**ADDENDUM:
Statement of Basis- Permit Minor Modification**

PERMITTEE:	United States Department of the Air Force (DoAF)
FACILITY NAME AND ADDRESS:	United States Air Force Academy (USAFA) Municipal Separate Storm Sewer System (MS4) 8120 Edgerton Drive US Air Force Academy, CO 80840
PERMIT NUMBER:	COR-042007
RESPONSIBLE OFFICIAL:	Col Ahave Brown Commander, 10 th Air Base Wing 719-333-1010 ahave.brown@us.af.mil
FACILITY CONTACT:	Dan Wilcoxon Deputy Director 10 Civil Engineering Squadron 8120 Edgerton Drive US Air Force Academy, CO 80840 719-333-2660 Daniel.Wilcoxon.2@us.af.mil
PERMIT TYPE:	Federal Facility, Municipal Separate Storm Sewer Systems, Permit Renewal
FACILITY LOCATION:	8120 Edgerton Drive US Air Force Academy, CO 80840 Latitude, Longitude: 38.9903, -104.8583
DISCHARGE LOCATION(S):	Multiple outfalls to: Smith Creek, Deadmans Creek, Monument Creek, Monument Branch, West Monument Creek, and Kettle Creek
RECEIVING WATERS:	Smith Creek, Deadmans Creek, Monument Creek, Monument Branch, West Monument Creek, and Kettle Creek

Permit and Statement of Basis (SoB) Modification Background:

Figure 3. Photo of outfall locations as provided by USAFA on undisclosed date. The western culvert was previously covered in vegetation.

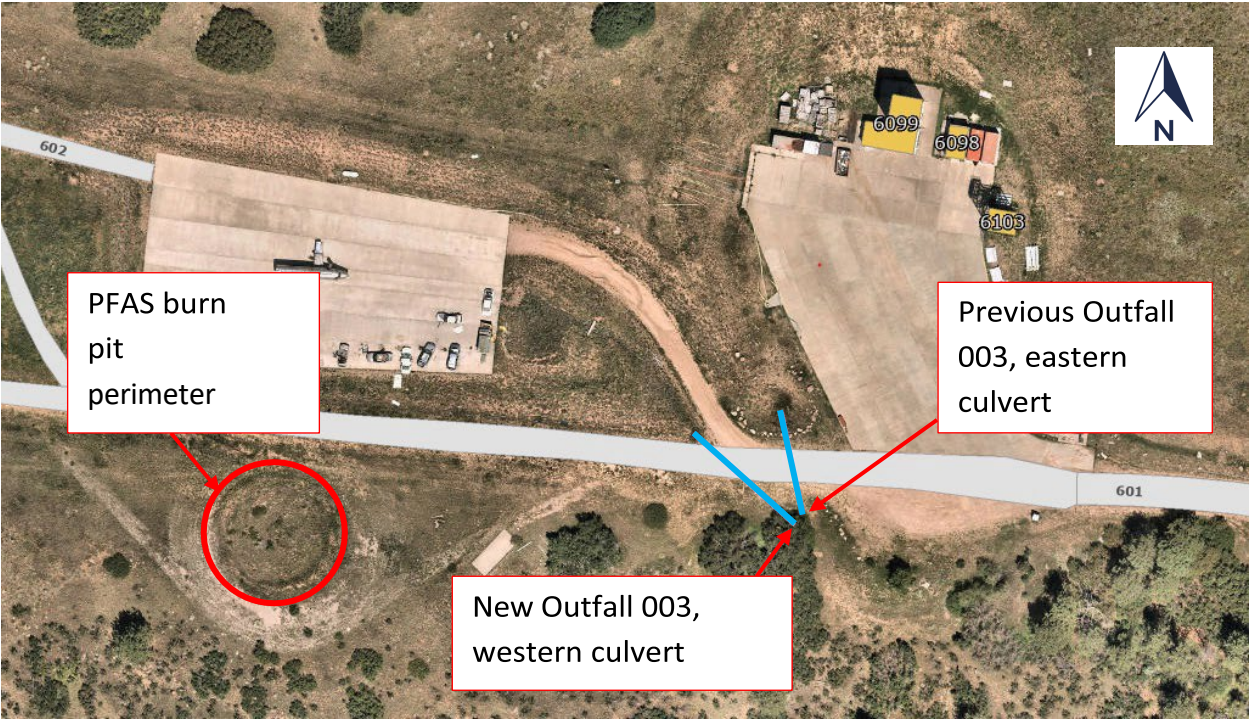
It was previously determined by USAFA that two separate culverts connected and conveyed stormwater to a single discharge point at Outfall 003 (Figure 1 below). This was again confirmed during EPA’s August 2023 inspection, in which the western culvert was obscured by vegetation (Figure 3 below) and was not identified. However, USAFA recently discovered that the culverts discharge separately at two distinct points located approximately 7 feet apart (Figure 2 below). The coordinates for the two locations are close enough that they are identical when rounded to four significant digits and are:

This modification will require USAFA to collect all stormwater samples for this location from the western culvert since it captures stormwater flows closer to the burn pit, which is the primary area of concern for PFAS. Based on USAFA’s interviews with base fire department personnel, PFAS was not sprayed on the concrete pads in the fire training area. PFAS was only sprayed into the burn pit areas during fire suppression training. No discrete outfall for the burn pit has been identified at this time. The original location of the eastern culvert for Outfall 003 was chosen because it was thought to be the closest location to the burn pit that had concentrated stormwater flow. However, the western culvert is closer and has been observed to have greater flow in springtime than the eastern culvert.

Given this new information, USAFA requested a modification of their permit to allow for more accurate PFAS sampling. EPA is hereby modifying the permit to require Outfall 003 be the following with the addition of “Sampling shall be conducted at the western culvert” to the below description from the existing Permit (in bold):
